NOTICE OF DECISION

CLASS 3 SITE PLAN REVIEW / CLASS 2 ADJUSTMENT / CLASS 2 DRIVEWAY APPROACH PERMIT / TREE AND VEGETATION REMOVAL PERMIT CASE NO.: SPR-ADJ-DAP-TRP25-10

NOTICE OF DECISION DATE: May 13, 2025

NEW DEVELOPMENT
GAS STATION CONVENIENCE STORE
MACLEAY ROAD SE, CORDON ROAD SE AND GAFFIN ROAD SE

1 SITE PLAN

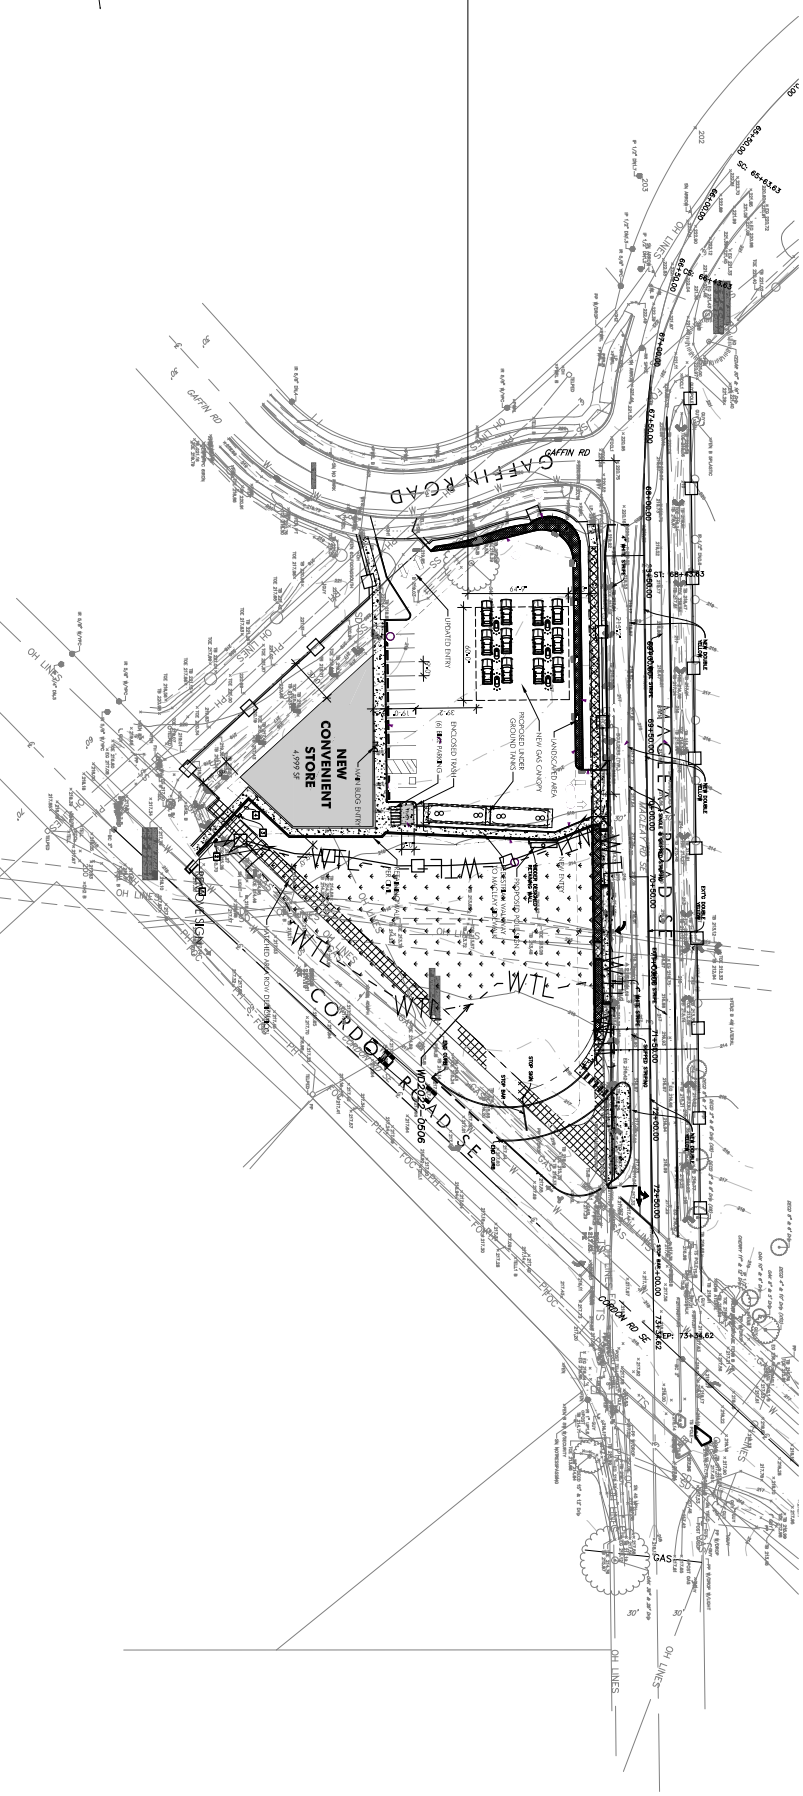
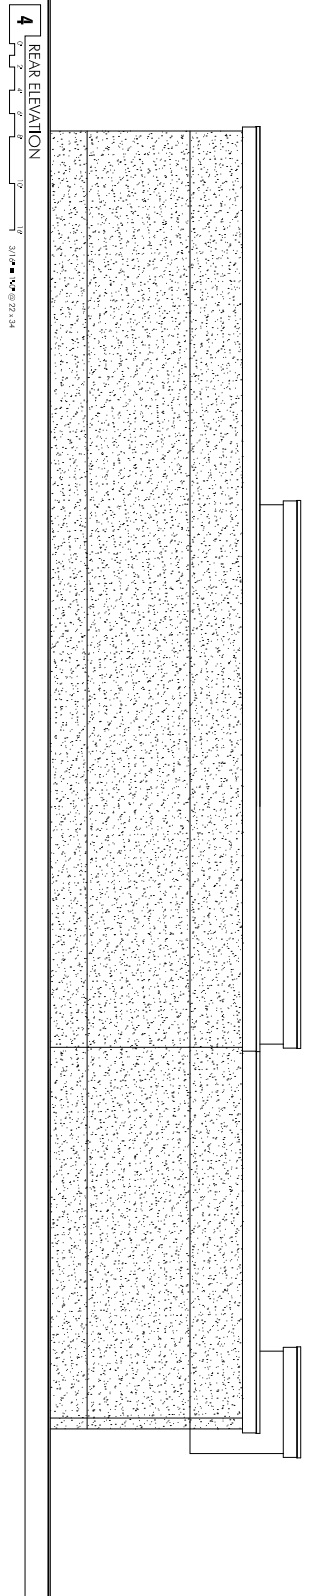
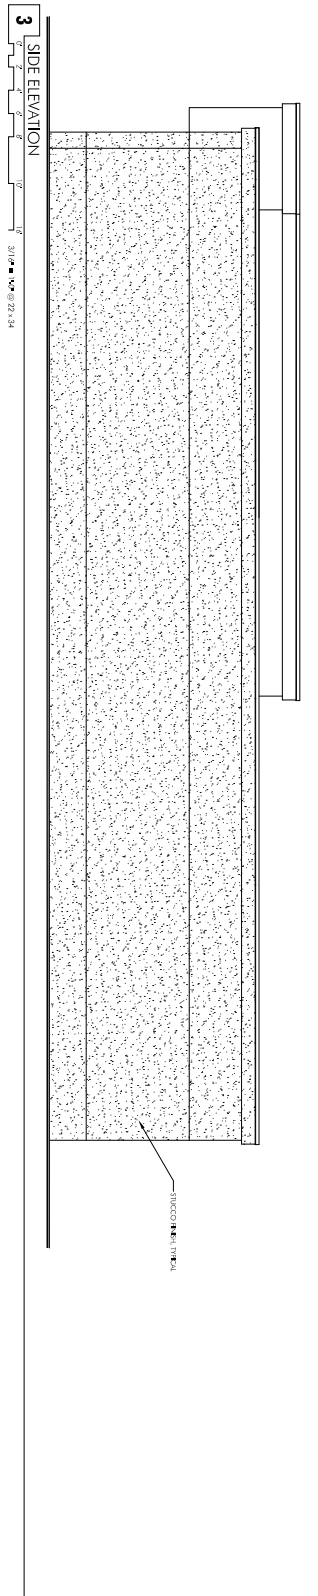
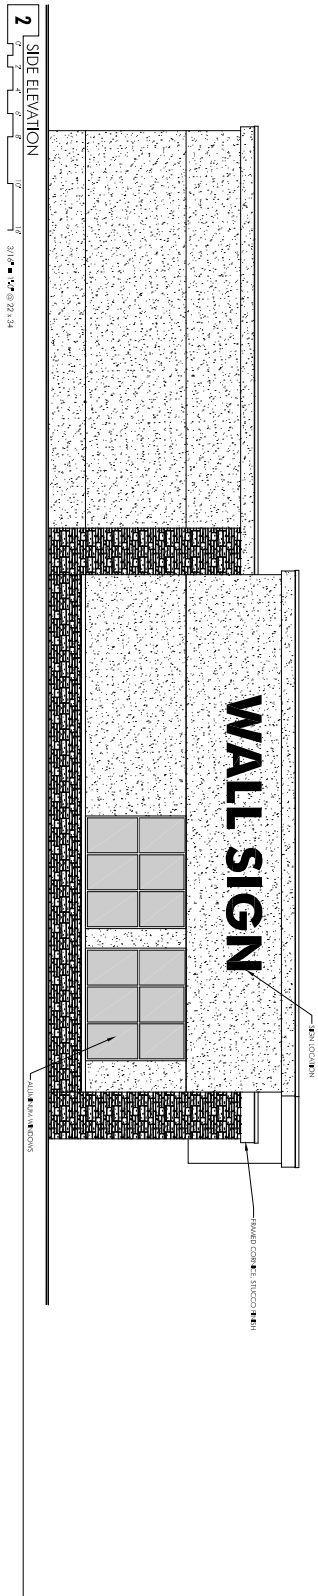
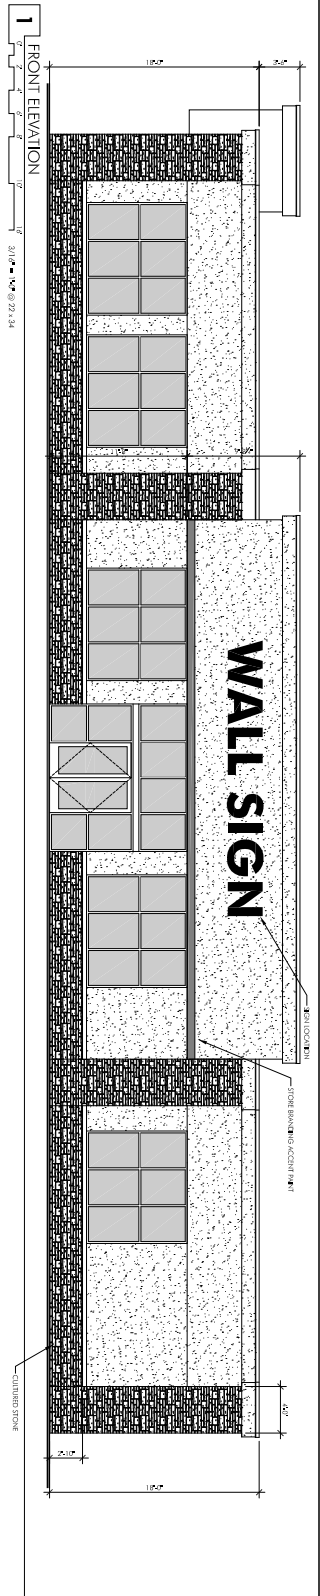
Finding: The proposed building is setback over 100 feet from both Macleay Rd; 18 feet from Cordon Rd; and more than 70 feet from Gaffin Rd, exceeding the minimum standard. The proposed fueling area includes a 3,600 square foot canopy, which is also setback 25 feet from Macleay, more than 250 feet from Cordon Rd, and more than 50 feet from Gaffin Rd. All vehicle use areas, including parking and drive aisles, are at least ten feet from the property lines abutting the streets except at the south end of the drive aisle for the fueling station abutting Gaffin Rd. The site plan indicates the setback tapers to approximately eight feet. To ensure the setback complies with the standards of this section, the following condition shall apply.

Finding: The proposed off-street parking area complies with all applicable location and perimeter setback requirements except at the south end of the landscape planter adjacent to the property line abutting Gaffin Road SE. As previously conditioned, this setback shall be revised to meet the minimum ten feet. As previously conditioned, landscaping will be further evaluated for compliance at the time of building permit review.

Finding: The applicant's engineer submitted a preliminary stormwater report that demonstrates the intent to utilize Green Stormwater Infrastructure, as required by SRC Chapter 71 and the Public Works Design Standards (PWDS). However, contributing areas and facility areas are inconsistent between plans and report figures, tables, and models in the preliminary stormwater report. The report also does not address all onsite impervious areas. Prior to issuance of a Building Permit, the applicant shall submit a final stormwater report that demonstrates the stormwater system will be designed and constructed in accordance with the Public Works Design Standards.

The applicant's site plan shows private, walled, green stormwater infrastructure facility placed in conflict within the sanitary sewer easement. Pursuant to SRC 802.020 and PWDS Section 1.8 (Easements), structures and other obstructions are not permitted within easements for City mains. Staff does not support this facility being located within the City's easement as it will obstruct access to the City's main for long-term maintenance. As a condition of approval, the applicant's site plan shall be revised to remove any conflict between private green stormwater infrastructure and public utility easements.

Condition 1: At time of building permit, provide revised plan to ensure the setback abutting Gaffin Road SE and the drive aisle to the fueling station meets the standards of SRC 806.035(c).

Condition 6: Design and construct a storm drainage system at the time of development in compliance with Salem Revised Code (SRC) Chapter 71 and Public Works Design Standards (PWDS).

Condition 9: Prior to issuance of a Building Permit, the applicant shall submit a revised site plan which removes any conflict between private green stormwater infrastructure and City main easements, unless otherwise approved by the Director.

1 TRASH ENCLOSURE PLAN VIEW

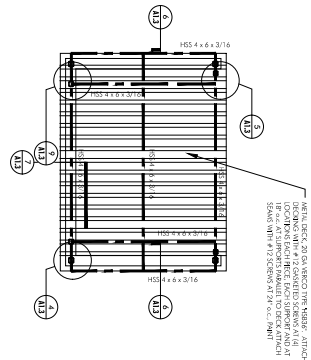
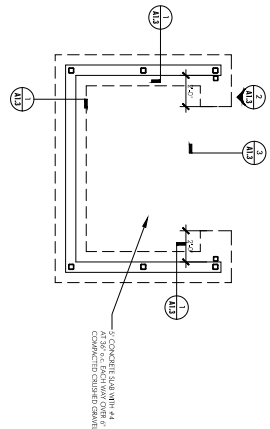
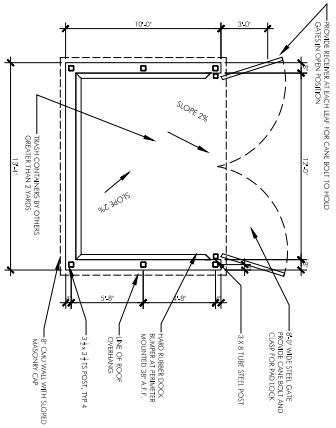
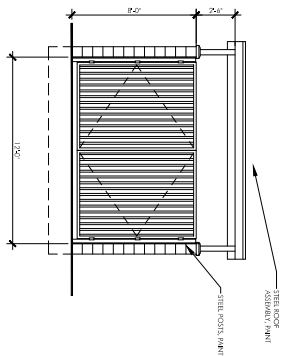
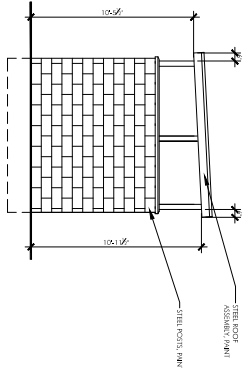
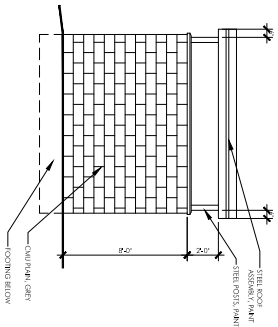
Finding: The applicant has provided construction details for the trash enclosure but do not show the separation of receptacles. As conditioned above, full adherence to these standards shall be met at time of building permit review.

Finding: The applicant has provided construction details for the trash enclosure showing receptacles greater than two cubic yards in size, requiring a minimum of 14 feet of unobstructed overhead or vertical clearance. The plans indicate a covered enclosure with a vertical clearance of 11 feet, which does not meet the minimum clearance height. As conditioned above, full adherence to these standards shall be met at time of building permit review.

Finding: The applicant's development plans show the proposed solid waste service areas will be within an enclosure made of CMU blocking and will only provide a four-inch bumper curb along the interior wall of the enclosure. As conditioned above, further conformance with the standard will be verified at the time of building permit review.

Finding: The applicant's development plans show an enclosure with a front opening of 12 feet in width. The plans indicate gate openings of only 72 degrees, which does not meet the

minimum 120 degrees. In addition, the construction details indicate restrainers used for the gates, but it does not clarify that they can be used in both the open and closed positions. As conditioned above, full adherence to these standards shall be met at the time of building permit review.

Finding: The construction details for the enclosure appear to show at least 14 feet of clearance for the front elevation; however, the side elevation does not appear to match the proposed 14-foot clearance, and the site plan indicates a clearance of only 11 feet. As conditioned above, these standards shall be met at time of building permit review.

Condition 3: At time of building permit review, provide detailed plans of the solid waste services area and enclosure meeting the standards of SRC 800.055.
